Item Name: Crosstube Turning Detail

DART AEROSPACE LTD	Work Order:	96771
Description: Crosstube Assembly (205/212/412 High Fwd)	Part Number:	D212-664-141
Inspection Dwg: D212-664-141 Rev: D		Page 1 of 2

DRAWING NO. D212-664-141	TITLE XTUBE ASSY (205/212/412 HI FWD)	REV. D	DART AEROSPACE LTD ENGINEERING ORDER		D.E.O. NO. D212-664-141-D-1	SHEET NO. SHEET 1 OF 2	SCALE NTS
DRAWN	CHECKED	MFG. APPR.	APPROVED	DE APPR.			
DATE 11.04.07	DATE 11.09.11	DATE 11.04.12	DATE 11/04/12	DATE 11.04.12

DRAWING NO. D212-664-141	TITLE CROSSTUBE ASS'Y (205 HI FWD)	REV. D	DART AEROSPACE LTD ENGINEERING ORDER		D.E.O. NO. D212-664-141-D-2	SHEET NO. SHEET 1 OF 1	SCALE NTS
DRAWN <i>UP</i>	CHECKED <i>ADS</i>	MFG. APPR. <i>AB</i>	APPROVED <i>MD</i>		DE APPR. <i>CH</i>		
DATE 11.07.15	DATE 11.07.20	DATE 11.07.21	DATE 11/07/21		DATE 11.07.21

**D212-664-141/-141B
ASSEMBLY DETAIL**

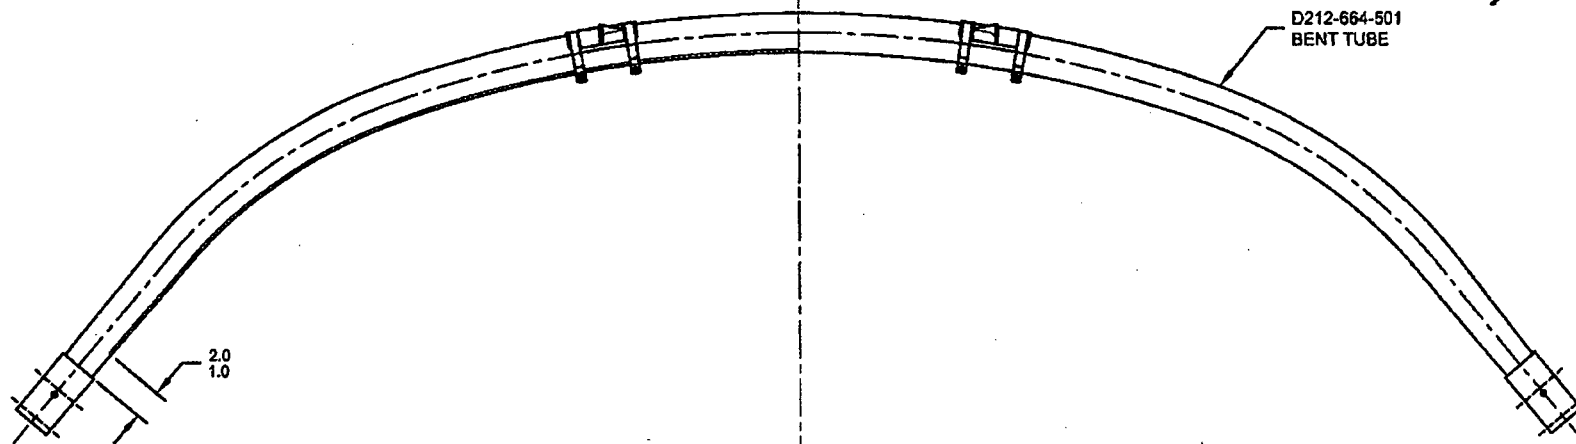
PURPOSE:

ADD AN INSPECTION WINDOW TO UNDERSIDE OF CROSSTUBE.

IS:

WAS:

MASK AREA PRIOR TO PAINTING,
REMOVE MASKING AFTER PAINT
AND APPLY CLEAR COAT
